Planning and Zoning Commission

March 6, 2024 – REGULAR MEETING

Meeting Date:	March 6, 2024	Meeting Title:	Planning Commission
Submitting Department:	Planning Department	Presenter:	Katelyn Page
Agenda Item:	P24-006 Request for a Conditional Use Permit at 105 Mercill Ave Units 101-103	Public Comment:	Yes

2Meeting Date:	March 6, 2024	Meeting Title:	Planning Commission
Submitting Department:	Planning Department	Presenter:	Tyler Valentine
Agenda Item:	Development Plan for a new 2-story, 12,366 sf bank at the property addressed at 380 S. Highway 89 (P23-226)	Public Comment:	Yes

C1.1

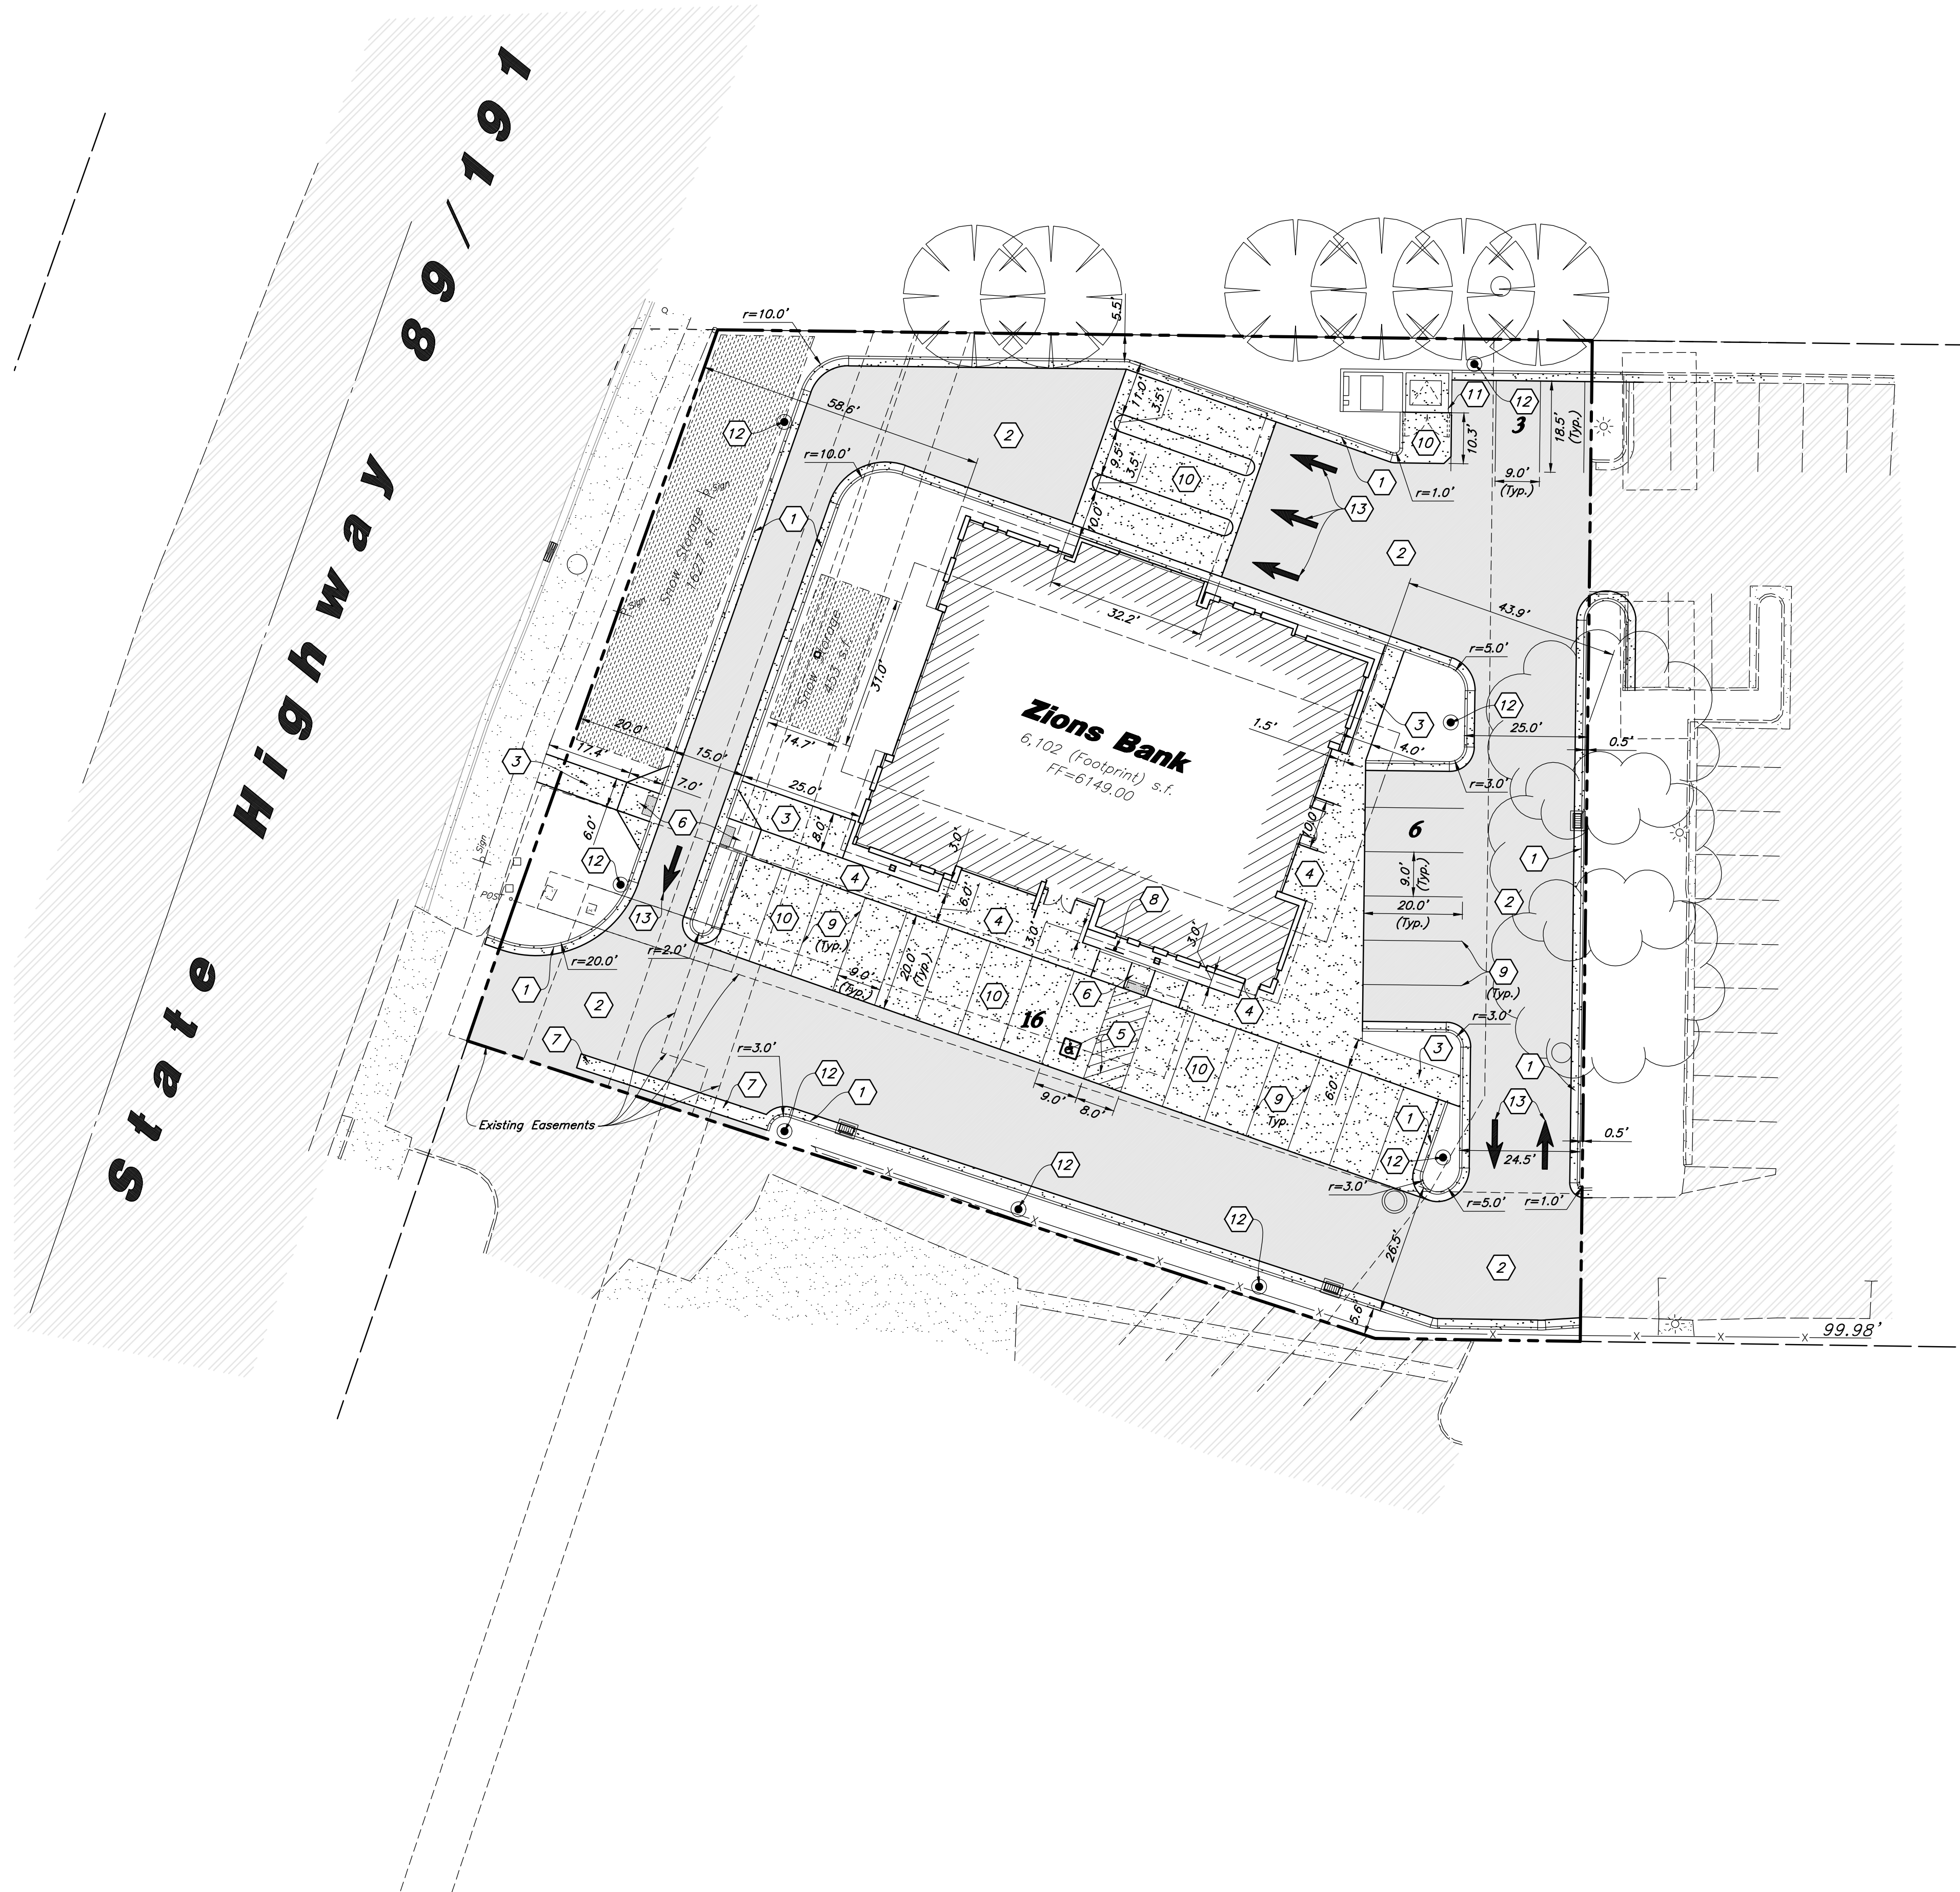
1. Prior to Town Council review, the applicant shall provide at least 1.25 plant units (Plant Unit Alternative C) within the 20’ front landscape buffer. In addition, the overall landscape plan shall shift additional vertical plantings in front of the building consistent with the purpose of the landscaping standards to screen and soften physical development.

2. Prior to Town Council review, the applicant shall revise the landscape plan and remove and replace all fruit-bearing trees and shrubs.
3. Prior to Town Council review, a ‘Trees in Lawn’ pedestrian frontage shall be provided along the highway.

The current pedestrian improvements adjacent to the subject property include an 8' attached buffer zone with pavers and a 4'-4.5' detached sidewalk. Although the CR-3 zone allows both Trees in Grates or Trees in Lawn, staff is recommending Trees in Lawn which would match with the existing lawn to the north along the Albertsons property. Trees in Lawn requires a 5' wide landscape buffer with trees spaced 30'-40' apart and a 6' detached sidewalk. A condition of approval has been added requiring that Trees in Grates be shown on the plans prior to Town Council review. One thing to mention is that South Highway 89 right-of-way is owned by the Wyoming Department of Transportation (WYDOT). WYDOT will need to review and approve all proposed improvements and there is a chance WYDOT may not allow trees along the street as they can conflict with plowing/snow storage operations depending on the type and size of tree. At this time staff has not received final review comments from WYDOT on this matter. In the event WYDOT prohibits street trees in the right-of-way, those required street trees will need to be provided on-site since they are required by the LDRs.
